**Red Dog Mine
Closure and Reclamation Plan**

**RED DOG CREEK REDIVERSION
DESIGN CRITERIA AND PLAN**

ADDENDUM

Subject: **Asbuilt of Red Dog Creek Rediversion**

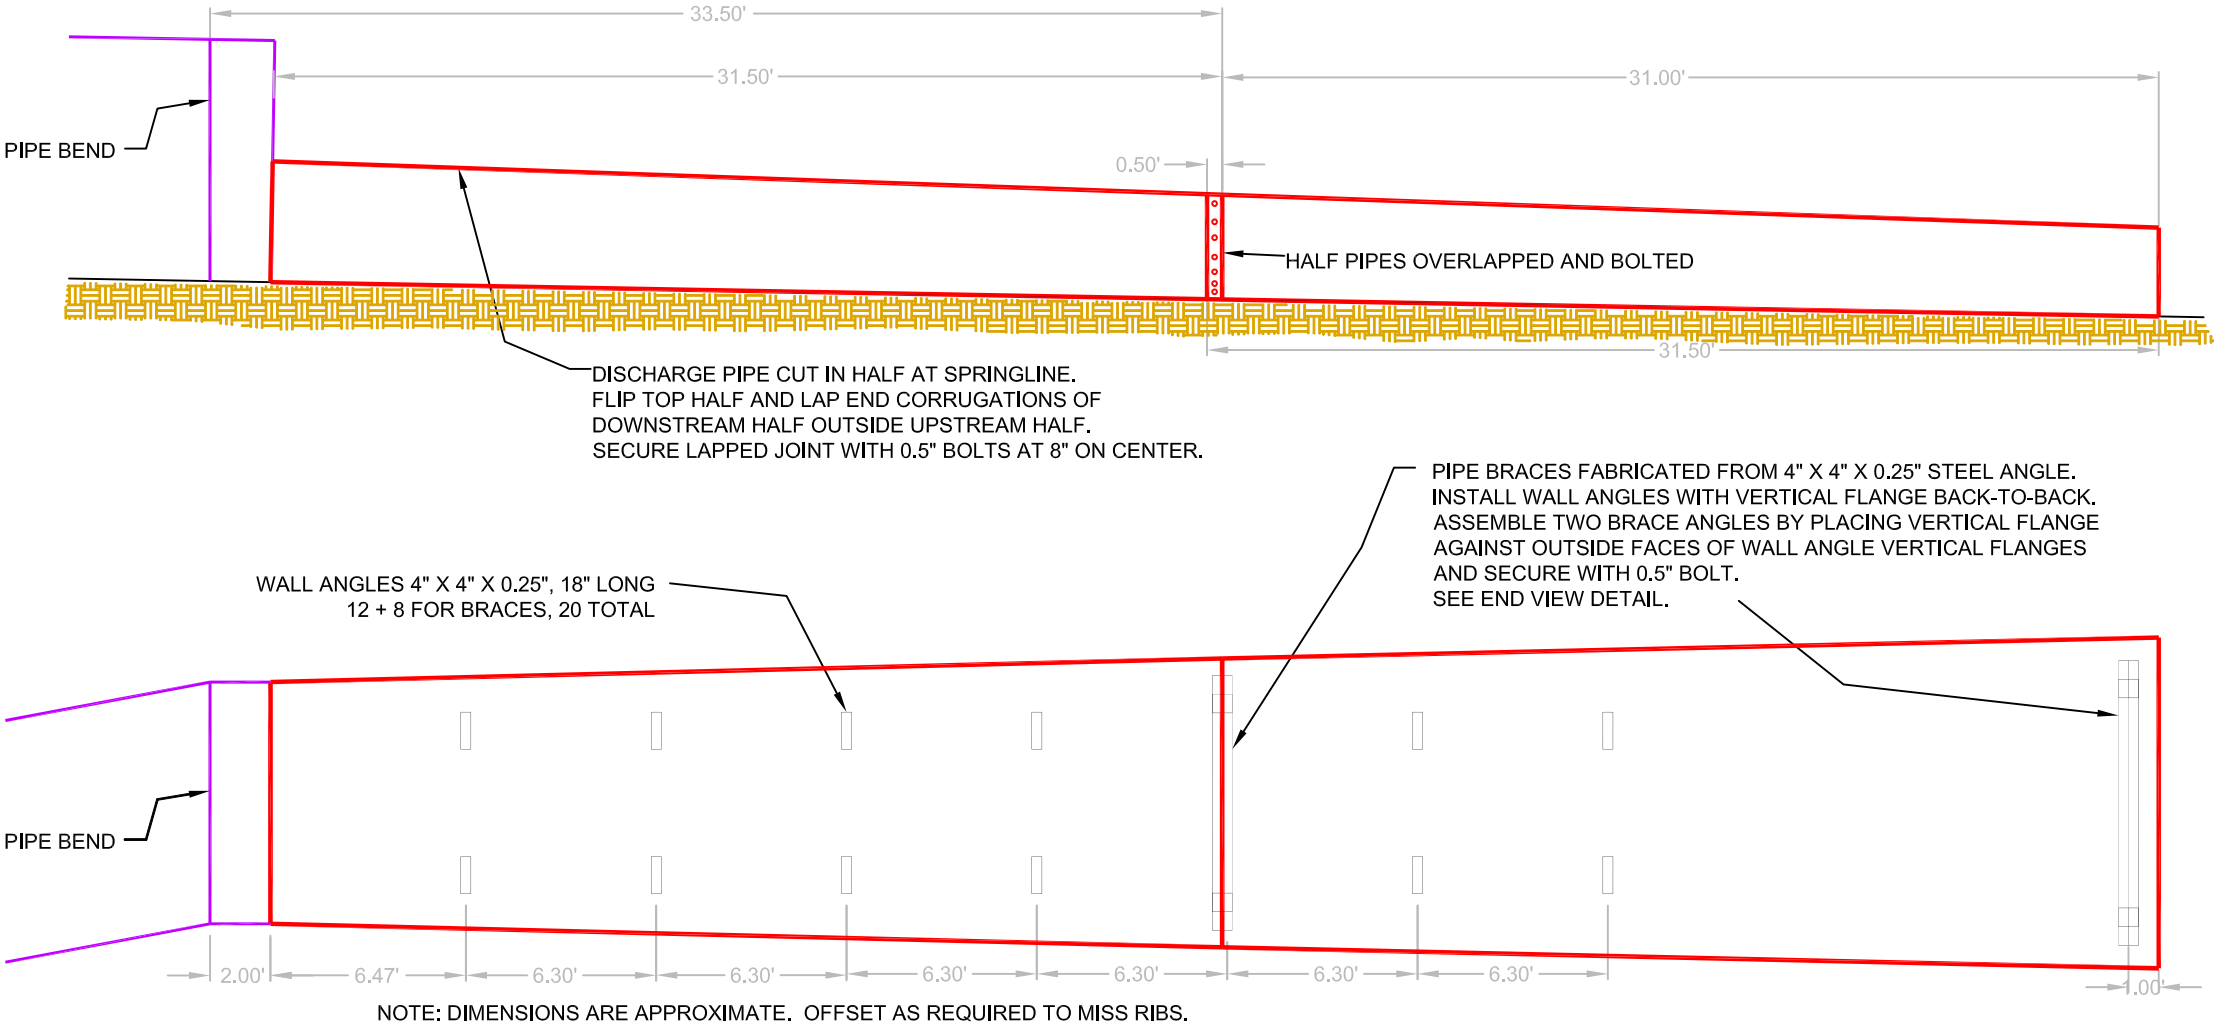
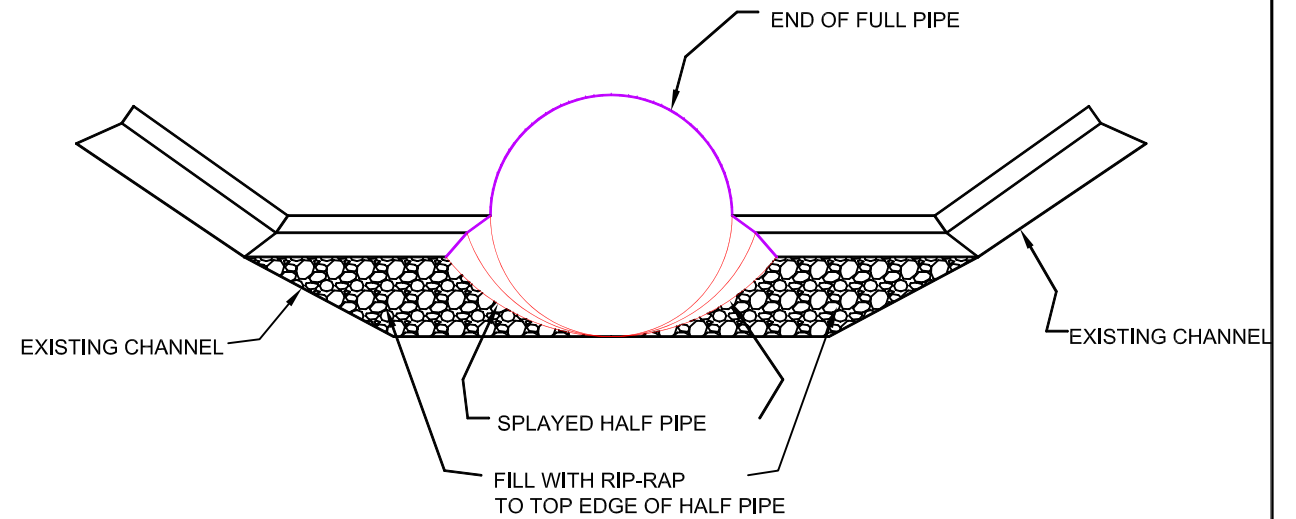
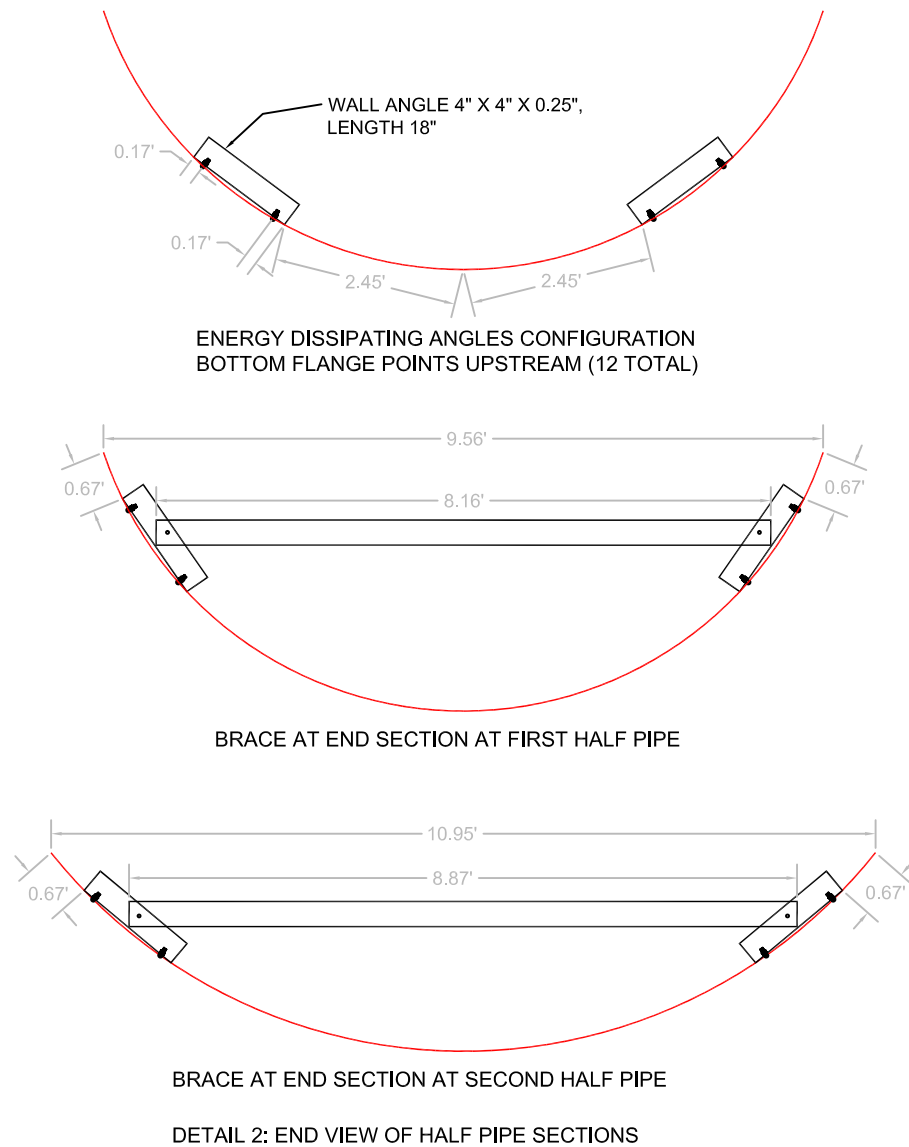
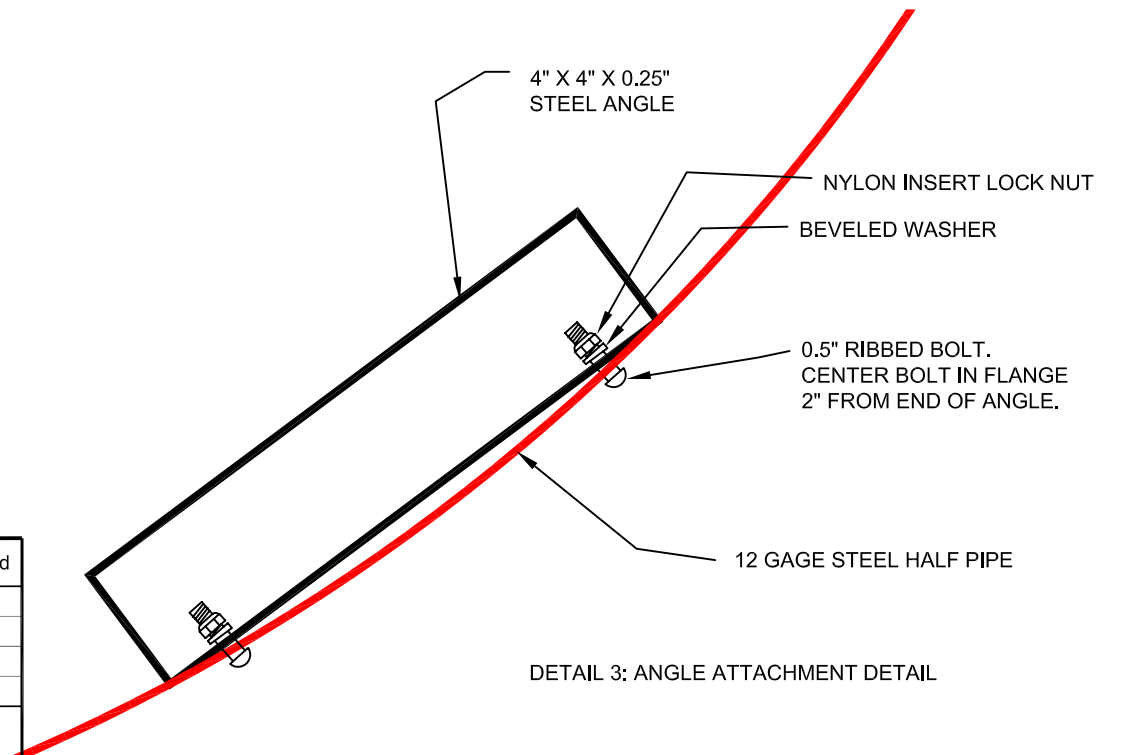
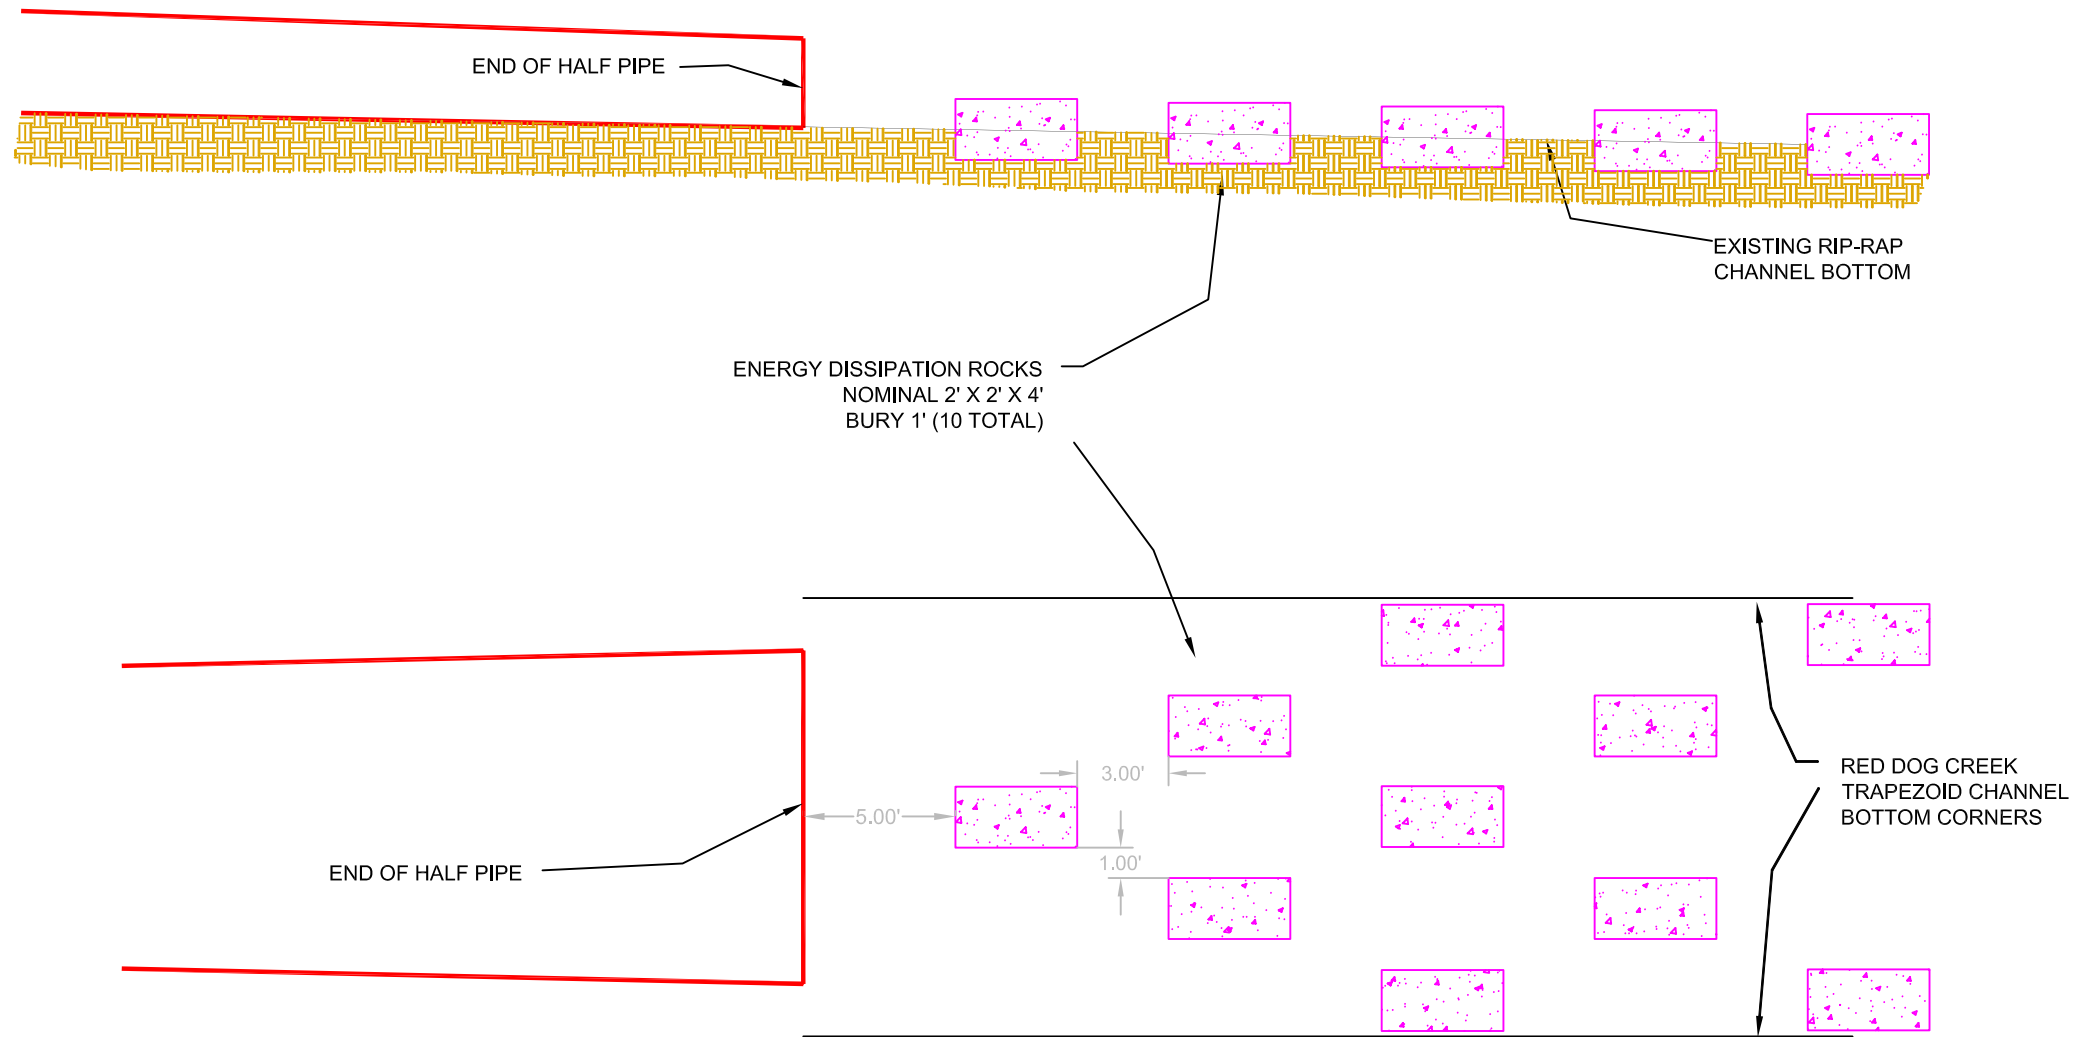
The cross-braces inside the half-pipe section of the 8ft culvert outlet have been removed due to ice jamming upstream of the braces. For the same reason the energy dissipation boulders have not been installed downstream of the outlet.
